## **DEVELOPMENT REVIEW COMMITTEE MEETING AGENDA**

DRC Meeting Draft Minutes  
Holden Avenue Planned Development  
August 10, 2021, at 11:00 am

**To:** Development Review Committee  
**From:** Brett Sollazzo, Deputy City Clerk  
**Date:** January 31, 2022  
**Re:** Haven Oaks Proposed Planned Development

Project: Haven Oaks Development Plan/Preliminary Subdivision Plan

PROJECT NO.  
1930  
SCALE  
1"=30'  
DATE  
Jan 2022  
SHEET  
A-101

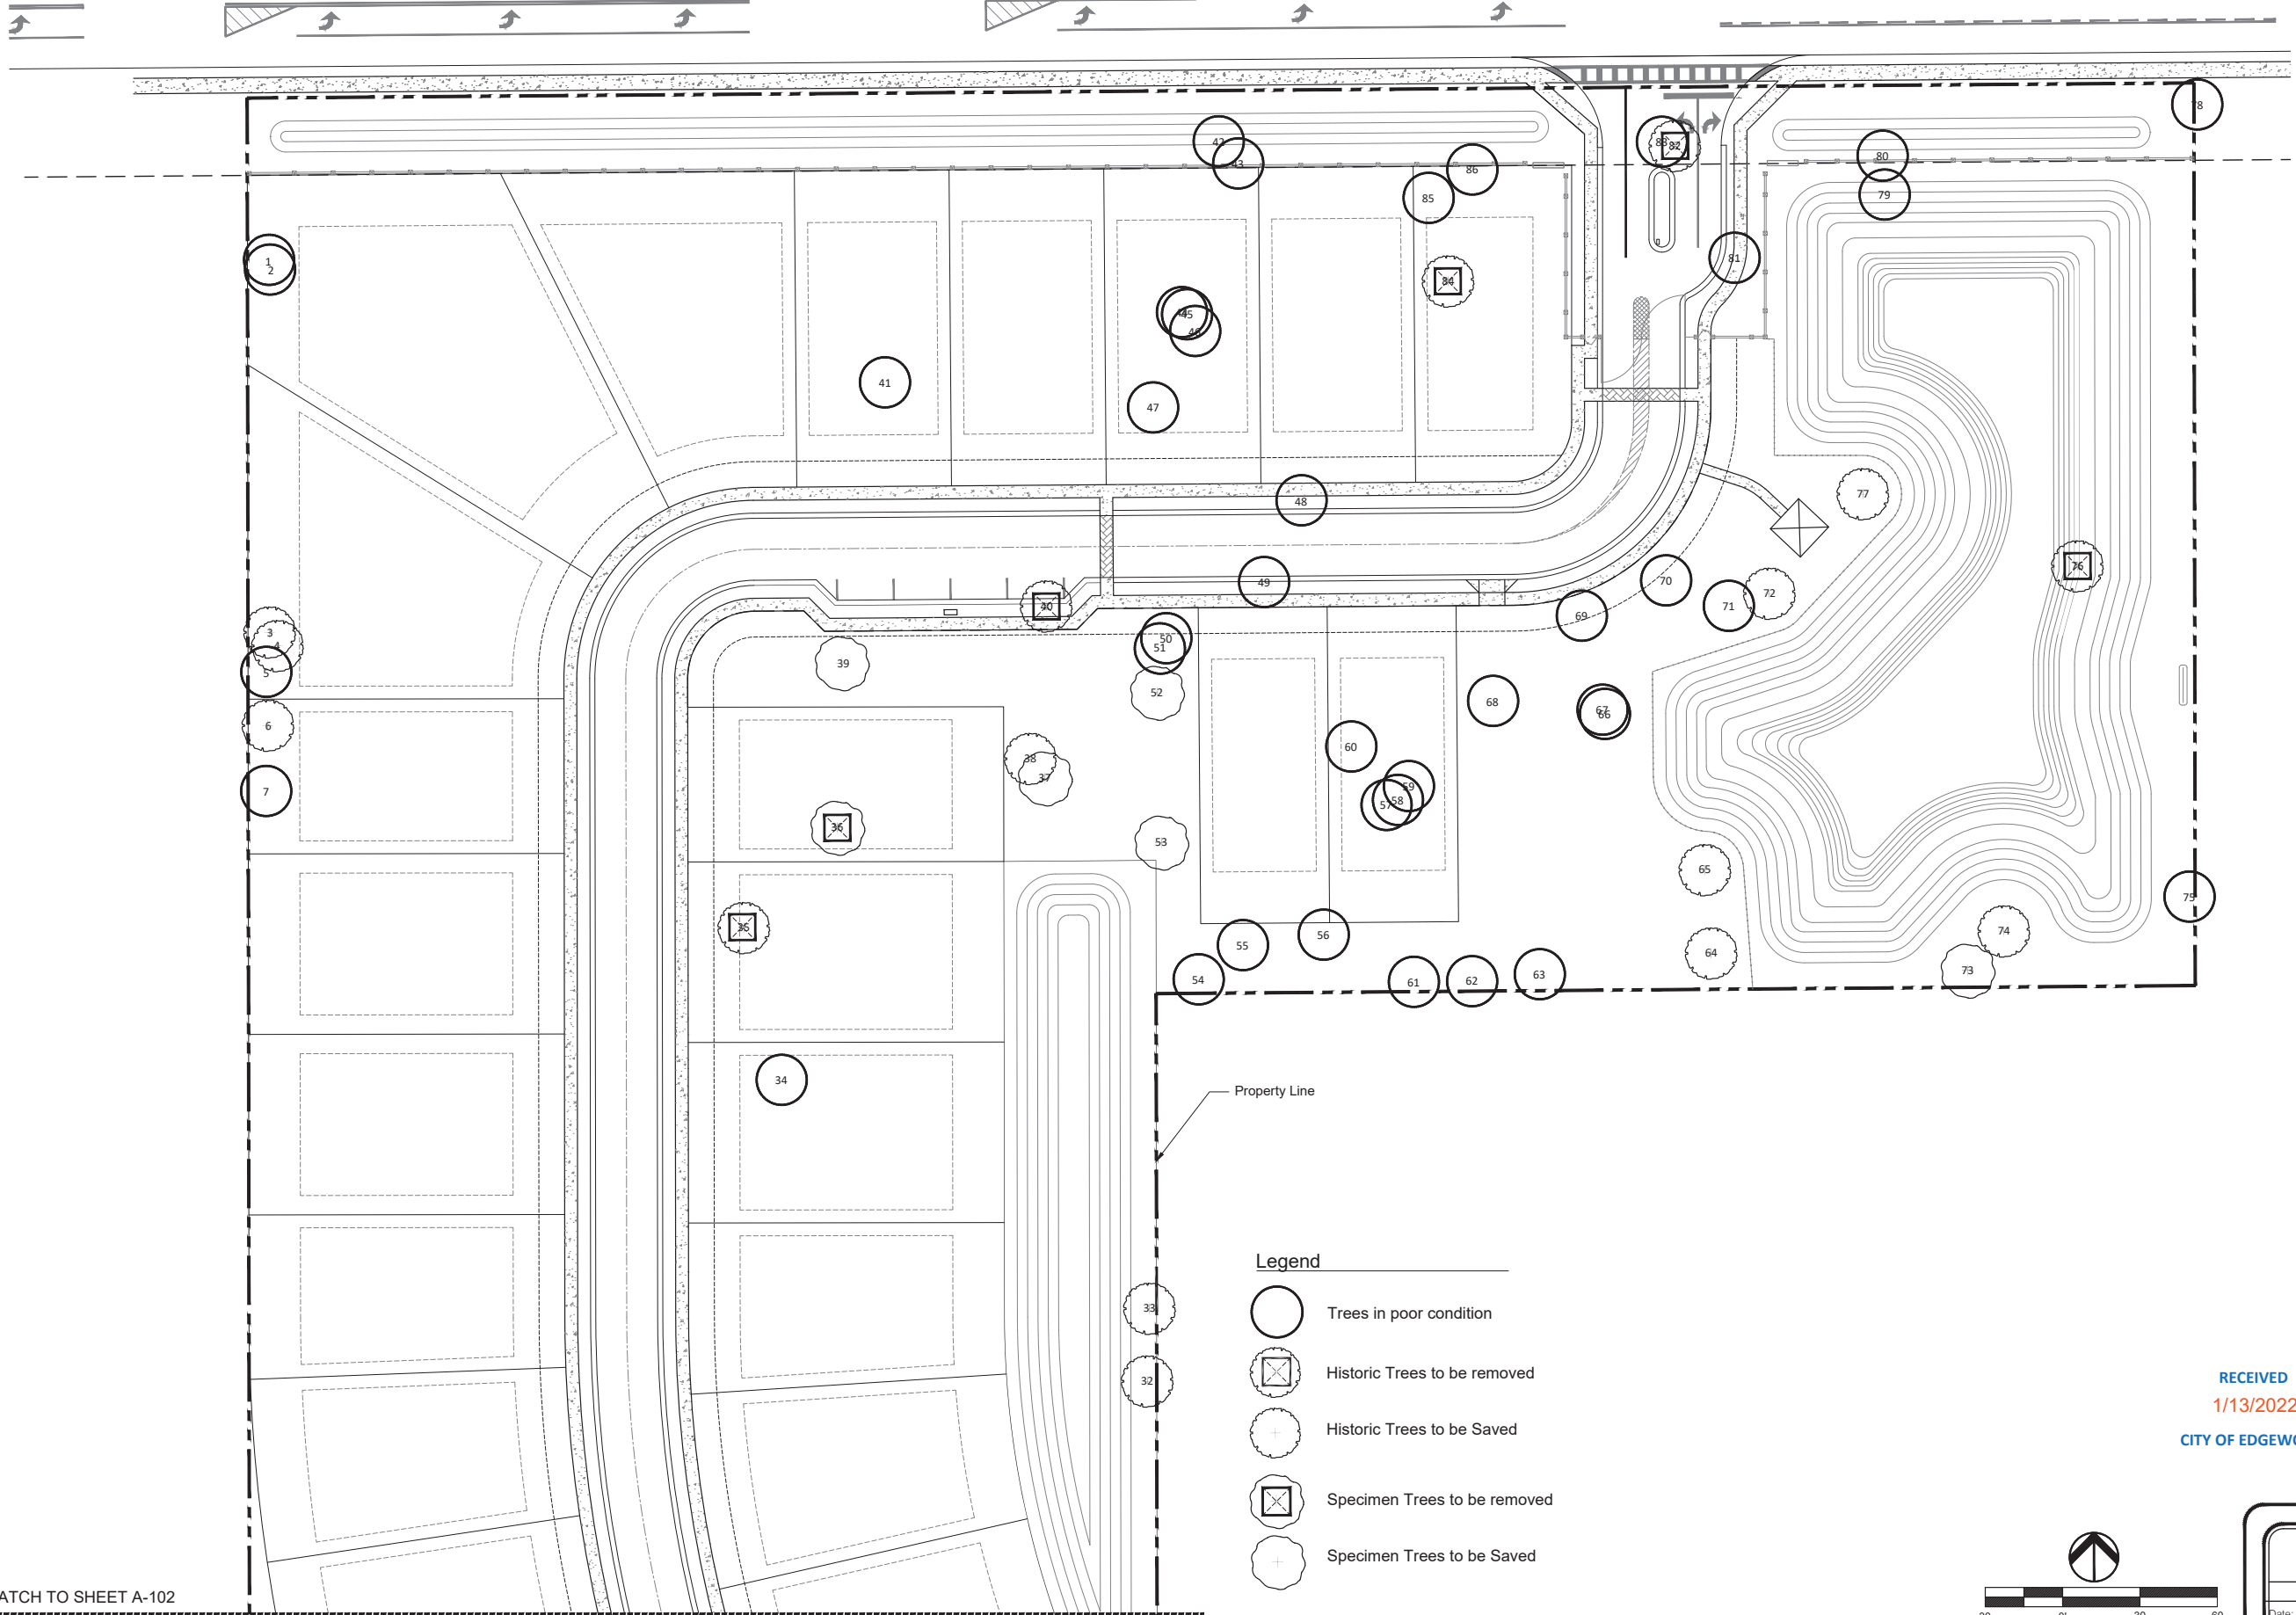
17. Is the illustrated access to stormwater pond SW4 practical? The “Tree Removal & Saved Plan” shows three historic or specimen trees will limit the currently proposed access width to the pond.

34. Sheet C-200: Is the illustrated access to stormwater pond SW4 practical? The “Tree Removal & Saved Plan” shows three historic or specimen trees will limit the currently proposed access width to the pond.
